**FINAL REPORT  
VALUE ENGINEERING STUDY**

**Southwest Regional  
Water Supply (SWRWS)  
Project**

New Mexico Interstate Stream Commission

**November 2014**

**P01-031**  
GILA RIVER  
DIVERSION AREA FROM BHI FIGURE 5  
PASSIVE INTAKE SCREEN  
DETAILS

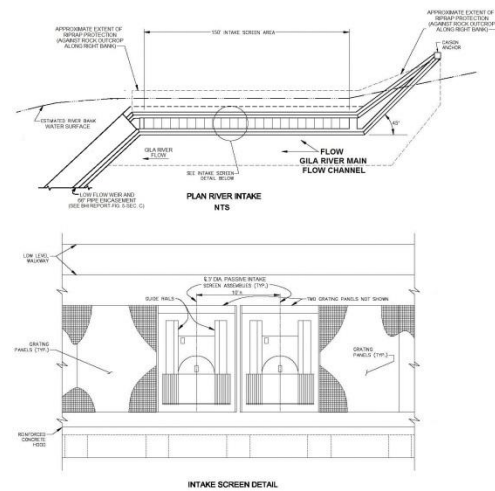
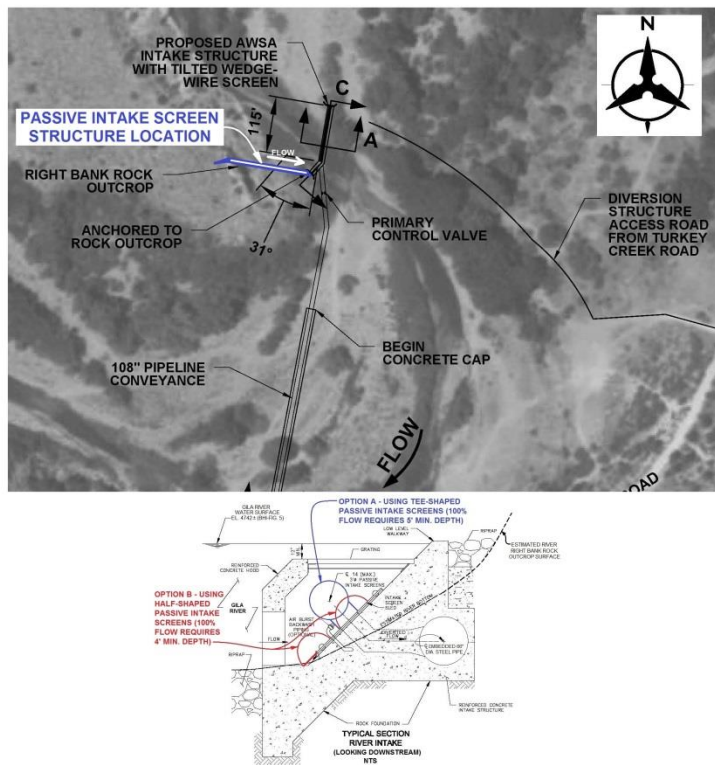
The use of submerged passive intake screens, which are similar to horizontal well screens supported by sloping concrete wall located in the river flow along the right abutment within the Gila River main flow area, would be accessible for maintenance from the right river bank. The passive intake screens would allow the 150 cfs minimum diversion flows to be diverted into the 108-inch diameter steel intake pipe regardless of Gila River water depth, even if the river was not flowing over the Coanda screen area. The passive intake screens would be designed to divert 150 cfs to replace the infiltration galleries and used in combination with the Coanda screens, which would divert up to 200 cfs, for a total maximum diversion flow of 350 cfs at the BHI diversion point.

The 150-foot long sloping reinforced concrete wall located along the right bank would support fourteen (14) 36-inch diameter passive intake screens (see photo below) to divert 150 cfs diversion flows from the Gila River. Each passive intake screen would be held in position by guide rails along the sloping concrete wall, which would allow screen removal for maintenance without entering or diverting the river flow. An additional airburst backwash can be used for automatic screen cleaning, but requires an air tank and compressor, which also requires electricity. The additional airburst system is not required, since the river flow around the screens will bypass most sediment, fish, and debris past the screen area.

The estimated construction and O&M costs for the reinforced concrete sloping wall and passive intake screens are substantially less than for the infiltration galleries. The estimated volume of reinforced concrete for the sloping abutment wall would be about 200 cy with a unit price of about \$1,000 per cubic yard for an estimated total concrete construction cost of about \$200,000. The stainless steel 36-inch diameter passive intake screens constructed and removable on the sloping concrete wall are about \$50,000 each for a total passive screen cost at about \$700,000. The total constructed

**Figure 1. BHI diversion structure design location within the Gila River floodplain.**  
(Source: Draft Final Gila PER, page 97/700).

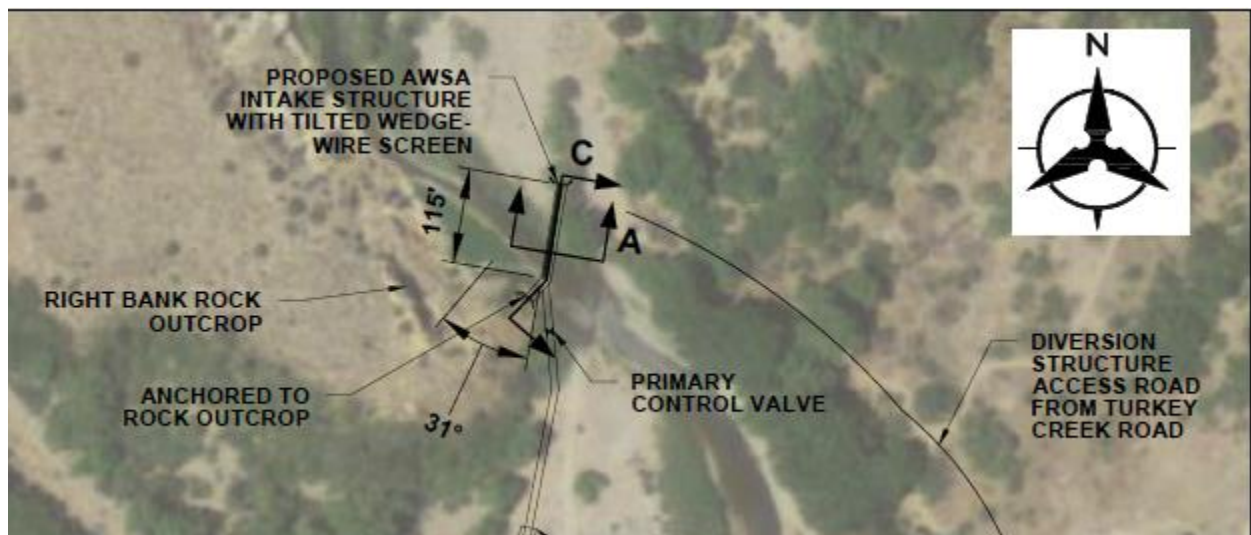
As currently proposed, the BHI design of the diversion structure does not span the entire floodplain (Figure 1)<sup>1</sup>. As can be seen in Figure 1, although the diversion structure is up to 130 feet in length, it does not appear to cover the active portion of the floodplain<sup>2</sup>. Hydraulic modeling prepared by the Bureau of Reclamation (BOR) and Mussetter Engineering, Inc. (MEI) indicate that floodplain velocities may exceed 5 ft/sec, which is above the threshold for erosion of some of the sandy floodplain soils. The historical channel movement analysis prepared by the BOR indicates that channel movement has occurred in the historic past within the active floodplain. Because flows within the active portion of the floodplain are capable of transporting sediment, scouring new channels, and relocating the channel by lateral erosion and/or avulsive channel processes during floods, the area should be considered to be subject to erosion risk. Also, overtopping of the active floodplain surface appears to be occurring on a less than 2-year frequency according to the BOR modeling. If overtopping during a 2-year or greater flood were to result in significant erosion, the diversion structure could be flanked and rendered ineffective until it was repaired.

Repair of a flanked diversion structure could be delayed by availability of funds, environmental permitting requirements for in-channel work, and the time required to assess, design, and mobilize the repairs. This could result in periods from weeks to years to perform the repairs and re-start the diversions.

Therefore, it is recommended that diversion structures, at minimum, span the active portion of the floodplain and tie into stable surface at low risk of erosion that would result in flanking of the diversion structure. For the purposes of this proposal, the conceptual diversion design proposed by the BOR and shown in Figure 3 is recommended for comparison purposes with the BHI design.
